UNITED STATES PATENT AND TRADEMARK OFFICE

APPLICATION NO.	FILING DATE	FIRST NAMED INVENTOR	ATTORNEY DOCKET NO.	CONFIRMATION NO.
10/812,349	03/30/2004	Tomoo Iijima	040158	2684
38091	7590	03/01/2006	EXAMINER	
TESSERA LERNER DAVID et al. 600 SOUTH AVENUE WEST WESTFIELD, NJ 07090			LE, THAO X	
			ART UNIT	PAPER NUMBER
			2814

Office Action Summary

DETAILED ACTION

FIG. 13G
(PRIOR ART)

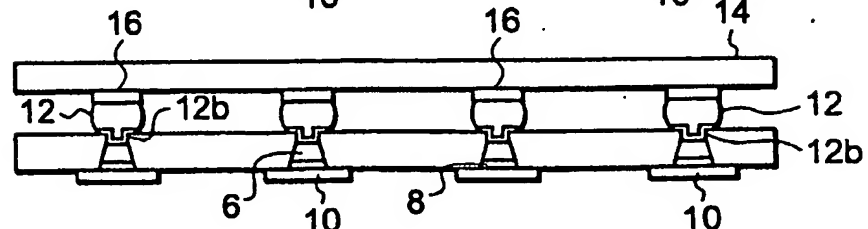
However, APA discloses the wiring circuit panel as claimed in claim 52 wherein said tops of each of said plurality of metal bumps 6 include an upwardly facing concave surface, fig. 13G, and said plurality of solder balls 12 contact said concave surfaces of said plurality of metal bumps 6. At the time the invention was made; it would have been obvious to one of ordinary skill in the art to use the concave surface the teaching of APA with Takubo's device, because it would have provided a better mating surface for the solder ball. Furthermore, the Applicant has no support data, which convinces that the particular claimed configuration is significant or is anything more than one of numerous configurations a person of ordinary skill in the art would find obvious for the purpose of providing mating surfaces. In re Dailey 149 USPQ 47, 50 (CCPA 1966). See also Glue Co. v. Upton 97 US 3,24 (USSC 1878).
